City Planning Commission  
Sacramento, California

- SUBJECT:
1. Negative Declaration.
  2. Rezone 16+ vacant acres from Agriculture (A) and Highway Commercial (HC) to the Townhouse (R-1A) Zone
  3. Tentative Map (Subdivision Ordinance)
  4. Subdivision Modification to Create Reverse Frontage Lots (Section 40.326, Subdivision Ordinance)
  5. Special Permit to Develop 71 Zero Lot Line and 38 Halfplexes (Section 7-C, Zoning Ordinance)

LOCATION: Southwest corner of Bell Avenue and Taylor Avenue

REVISED MAP  
TENTATIVE MAP FOR  
**CEDARLEAF**  
CITY OF SACRAMENTO, CALIFORNIA

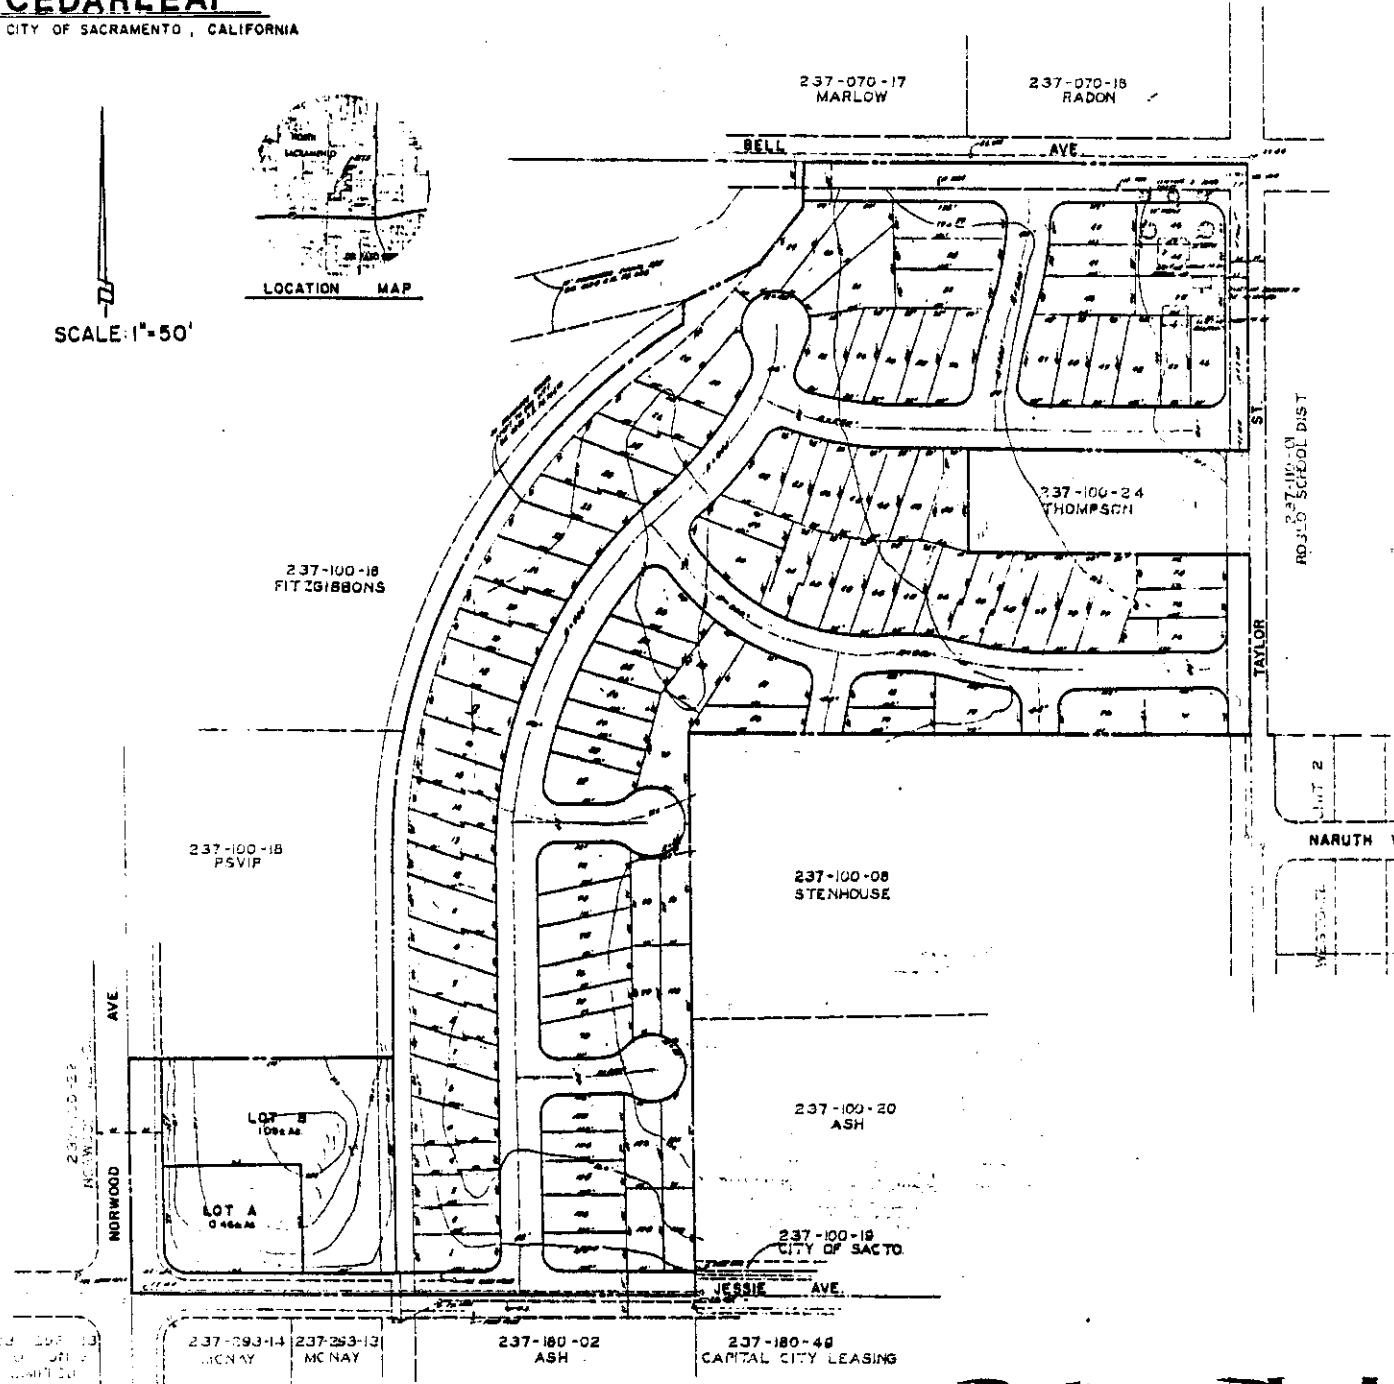
The City Traffic Engineer has indicated that all intersections must intersect at 90 degree angles and that streets designed with a reverse curve must be provided with a tangent section between the curves. This will require some modification of the street design. The applicant has been informed of these requirements and has indicated that the required street modification will not significantly alter the project design.

In light of the modifications submitted by the applicant, staff has no objections to the proposed development. The changes which have been made in this project address the concerns expressed by staff over the design of the original proposal. Staff also supports the requested subdivision modification to create lots with reverse street frontages since front-on lots along Bell Avenue are not desirable due to the close proximity of the canal bridge to the two lots in question. Staff does, however, object to the creation of Lot A and B on the far southwest side of the site which are being created for future commercial use. This use is not consistent with the new North Sacramento Plan or zoning. Staff is, therefore, requesting that Lot A and B be combined.

8. Dedicate the canal to the City.
9. Name the streets to the satisfaction of the Planning Director.
10. Dedicate all interior streets, except cul-de-sacs, and the southern most east/west street which will be 44' right-of-way, to a 50 foot right-of-way.
11. Off-site improvement, except for sidewalk, required across Thompson Property (City will condemn at the owner's expense).
12. The map shall be redesigned by combining Lots A and B on the far southwest corner of the property.

# CONCEPTUAL SITE PLAN

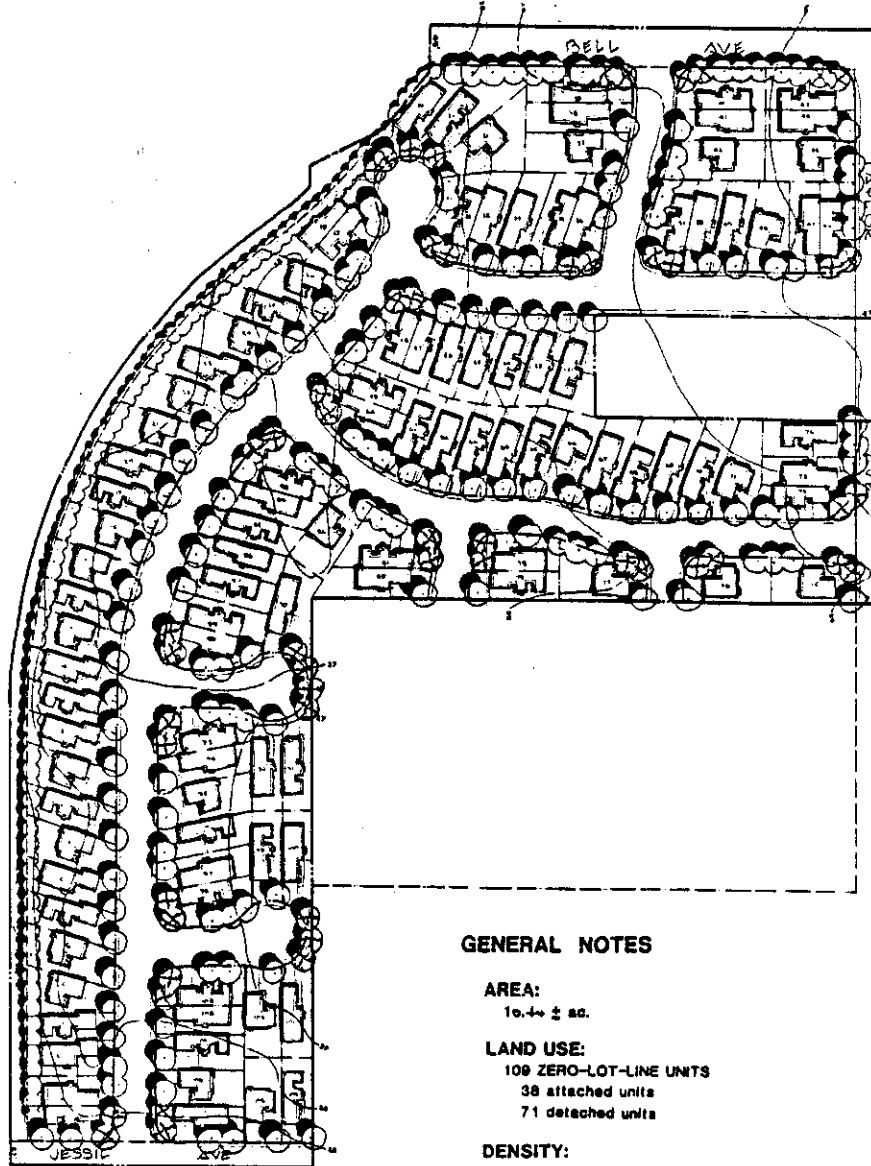
1. The applicant has varied the setbacks of the units along the west side of the site from 15 feet to 30 feet. The maximum setbacks have been accomplished by relocating the Plan A units, which are not as deep as the other units, farther to the rear of the property. Staff suggest that the minimum frontyards will be landscaped with trees and low shrubs to soften the front elevations and enhance the streetscape. Heavy landscaping will also be provided along the drainage canal on the western property line and along Bell and Taylor Avenues.

1. There shall be a minimum of 11 plan A units located along the west side of the north/south collector street. These units shall be dispersed along this street in a manner similar to the plans in Exhibit B. A final site plan shall be submitted for Planning staff review and approval prior to issuance of building permits.

2. The front setback of the units shall be varied from 20 feet to 30 feet throughout the project.
3. The applicant shall utilize the elevations in Exhibit C. The elevations shall be dispersed throughout the project. Plot plans and elevations shall be submitted to Planning staff for review and approval prior to issuance of a building permit.

**PRELIMINARY LANDSCAPE PLAN**

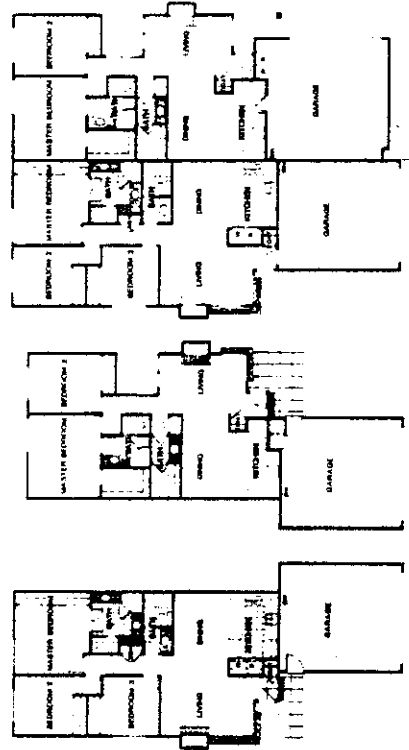
4. The applicant shall submit detailed landscape and irrigation plans for staff review and approval prior to issuance of building permits. All trees shall be a minimum size of 15 gallons. Dense landscaping and trees shall be provided along the rear property line of lots adjacent to the drainage canal.

ALTERNATE ELEVATION-UNIT A

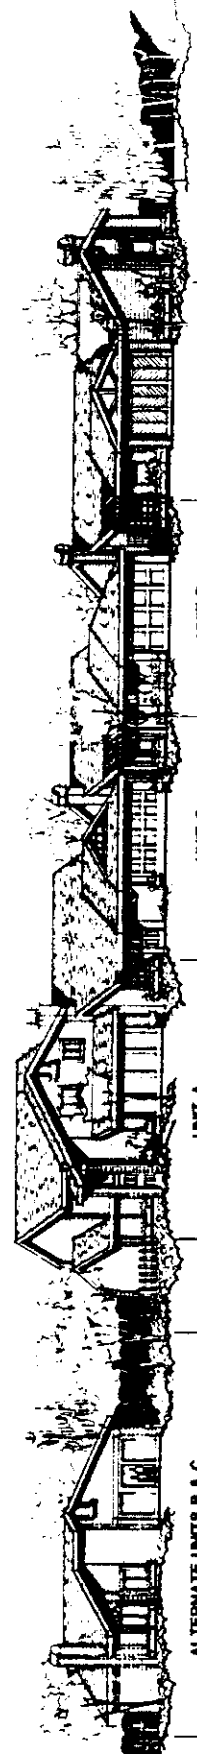
At the March 22, 1984 hearing, the applicant presented revised plans which included modified elevations and off-set property lines along with a proposed landscape plan for the development. The applicant modified the property lines and units by shifting the garage away from the main structure to allow for more unit orientation to the front of the lot on 17 of the zero lot line lots. This change was made to address staff concerns over the predominance of the garages along the streets in this project. The applicant also proposed certain modifications in the unit design with alternate roof lines and building materials.

# CONCEPTUAL SITE PLAN

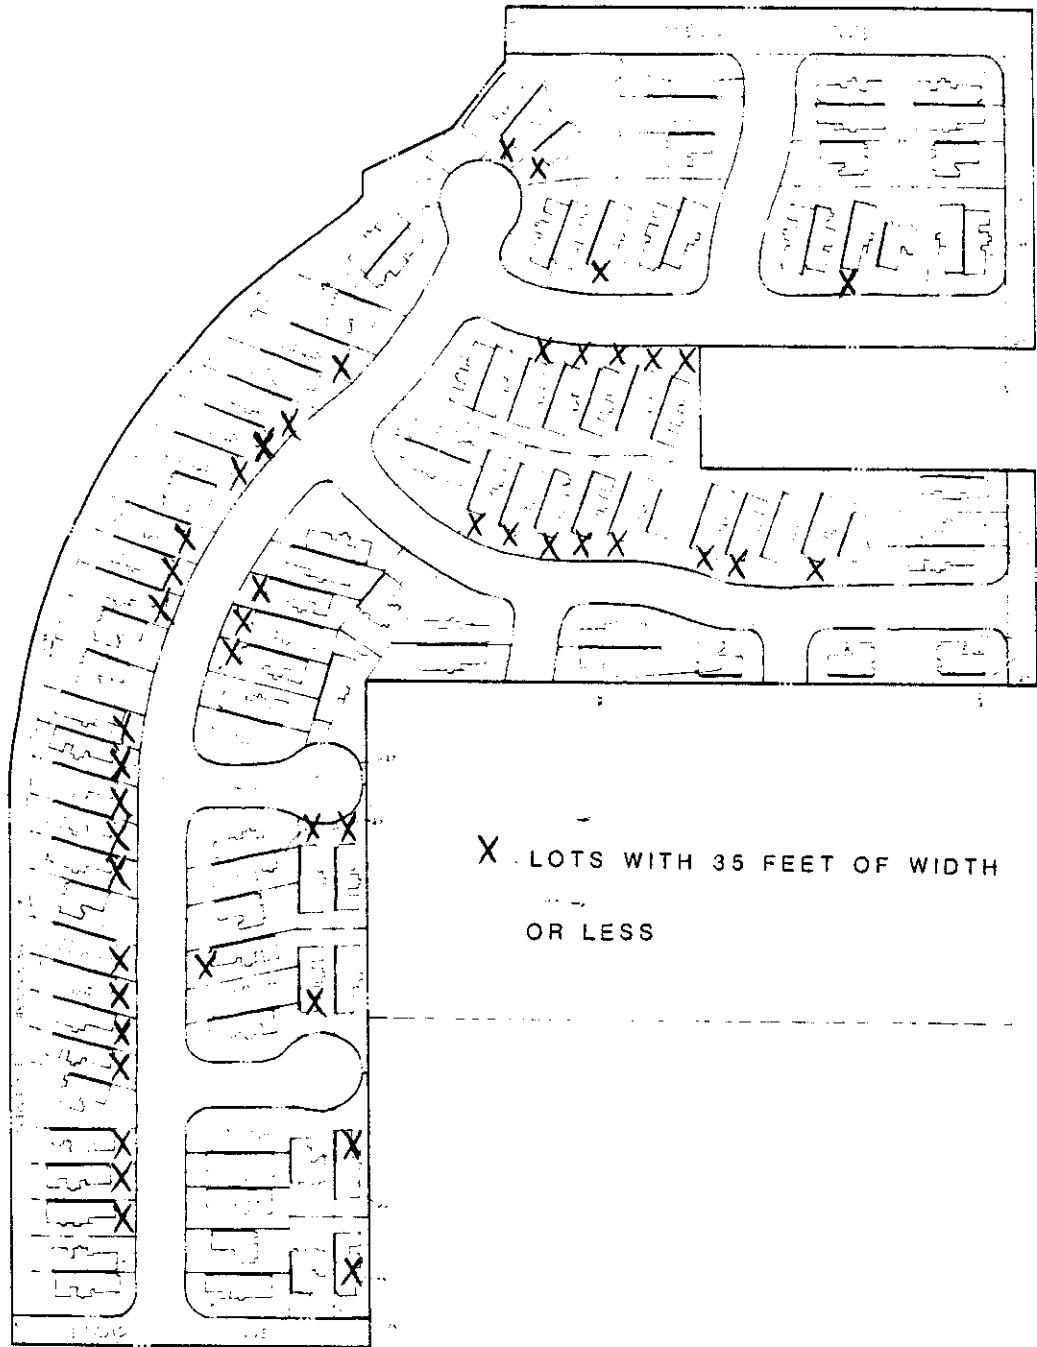
4. Although staff has no objections to the concept of developing the site with zero lot line and halfplex units, staff does have concerns over the design of this project. Forty-one of the proposed zero lot line lots in this development are 35 feet wide, four lots are 30 feet wide or less and because of the narrow lotting pattern the structure design is limited. As proposed, 83% of the units are only 25 feet wide which limits the possibility of solar access for a majority of the north/south oriented lots. The narrow lots have also created a situation where the minimum setback between zero lot line units is less than 10 feet, which has been the standard minimum setback approved for this type of development. This proposal indicates that the maximum setback achievable between some of the units is only 7-1/2 feet. A condition has been placed on the map to require a minimum of 10 foot setback between units, which may further reduce the width of some units.

5. Staff also has concern over the design of the structures. As proposed, the 25 foot wide units will be developed with little or no unit orientation on the street other than the garage. The predominance of garage frontages will create a monotonous streetscape and adversely affect the design of the neighborhood. In addition, the lack of street oriented units may create future security problems in that the living area of the structure will be isolated from the street and prevent the resident from monitoring neighborhood and street activity. In an effort to address staff's concerns over the structure design, the applicant submitted revised plans. In reviewing the applicant's revisions, staff finds no discernable difference between these plans and those originally submitted. The floor plans are substantially the same and the predominant feature on the front elevations are the garages.

6. As proposed, the applicant's plans indicate dual street frontage for two of the lots along Bell Avenue. The applicant proposes to develop these two sites with back-on lots which is contrary to the proposed residential design criteria for development adjacent to major streets. Staff has recommended these lots be redesigned using the proposed design criteria for subdivisions located on major streets. The applicant has, however, indicated that modification is not possible for these lots due to grading variation of the drainage ditch along Bell Avenue. The City Engineer indicated that front-on lots with access on Bell Avenue would not be possible due to the grading variation and close proximity to the bridge.

7. The applicant needs to propose major changes in an effort to gain staff support for the halfplex and zero lot line development. Staff recommends expansion of the lots to a minimum width of 45 feet. The roof lines should be changed to provide more variety on front elevations. In addition, the units should be widened to accommodate more exposure of the living area to the street.
